Memo

To: Cranston City Plan Commission
From: Alexander Berardo – Planning Technician / Administrative Officer
Date: September 30, 2022
Re: **Minor Subdivision without street extension - Preliminary Plan**
“Wayside Drive Plat – Replat of A.P 10, Lot 1041”

Owner/App: Bruce D. & Mindy B. Lane
Location: 90 Wayside Drive, AP 10, Lot 1041
Zone: B-2 (Single-family dwellings on 6,000 ft² minimum lots; Two-family dwellings on 8,000 ft² minimum lots)
FLU: Residential less than 10.39 units/acre

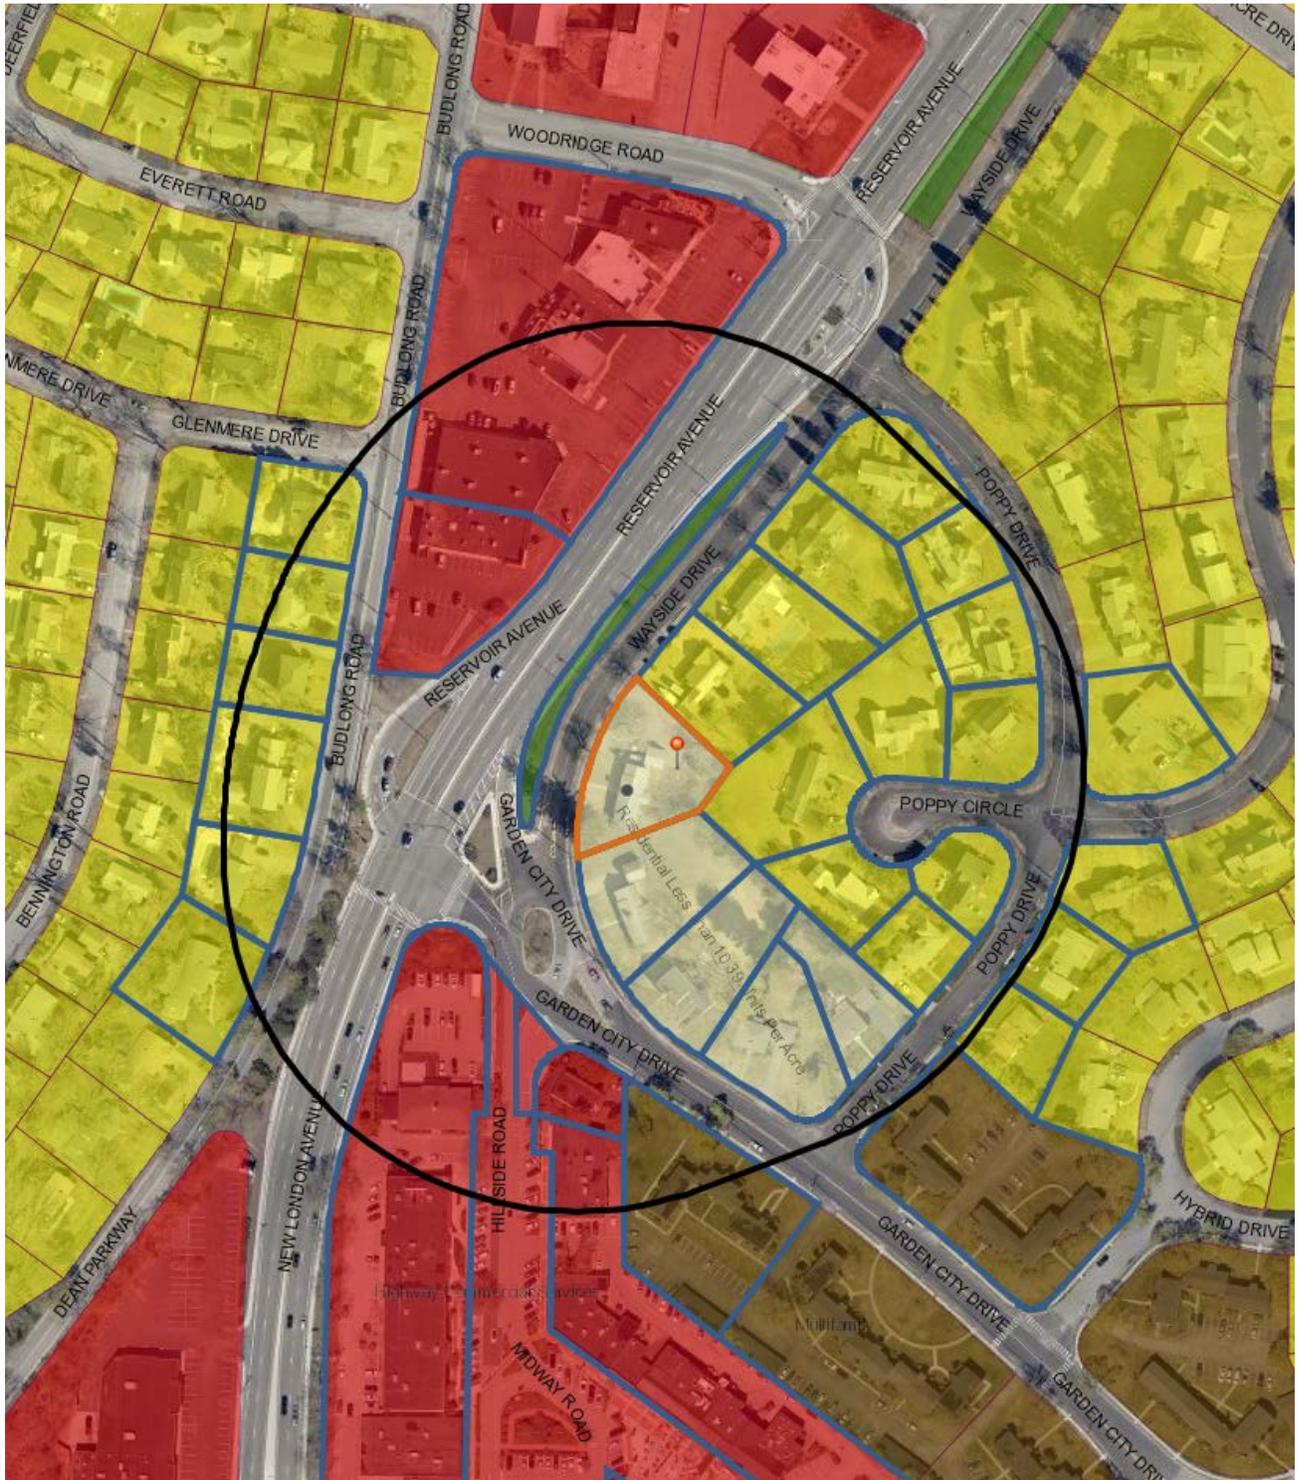
- DPW – Engineering: Chief Engineer Justin Mateus, P.E., reviewed the plans with Staff on September 15th. He said that the existing sewer lateral will need to be relocated because in its current layout, it can only service Proposed Parcel A by cutting across Proposed Parcel B. He added that Wayside Drive was paved in 2020, so any sewer work will necessitate a curb-to-curb pavement replacement, extending five feet past the utility trench on each side, with joints sealed using an infrared patch. Mr. Mateus also cautioned that the applicant's proposed driveway configuration (which would increase the number of curb cuts on the parcel from one to four) was not prohibited by code, but could enable increased amounts of stormwater runoff to spill onto the property, given the direction of flow. Finally, Mr. Mateus asked that the site plan be updated to show 1) the extension of the curb to the proposed shared lot line between Proposed Parcels A and B; 2) the new curb cut to be created for the southernmost proposed driveway; 3) add a "Pavement to be Removed" label over the portion of the existing driveway to be eliminated near the proposed shared lot line; and 4) to show and label the 10' Sewer Easement on the parcel.

- DPW – Sewer: Environmental Engineer and Veolia Water liaison Ed Tally contacted Staff on September 20th to recommend that the applicant establish an independent sewer lateral for

Proposed Parcel A that avoids the need for a sewer easement across Proposed Parcel B, consistent with the City's standard practice.

2. The applicant shall update the site plan to reflect the proposed curb cut, curb extension, pavement removal, and sewer easement as described by Mr. Mateus for Final Plan submission.
3. Prior to Final Plan recording, DPW and Veolia Water shall review and approve the final utility plan showing the location of an independent sewer lateral serving Proposed Parcel A and the removal of the portion of the existing lateral on Proposed Parcel B that extends beyond the proposed shared lot line onto Parcel A on the Final Plan.
4. Applicant shall submit updated easement documentation for review by DPW and Veolia Water as part of the Final Plan application.
5. Payment of the Eastern Cranston Capital Facilities impact fee in the amount of \$1,186.92 (2 new units at the rate of \$593.46 per unit, as shown on the site plan) must be submitted at the time of final plat recording.
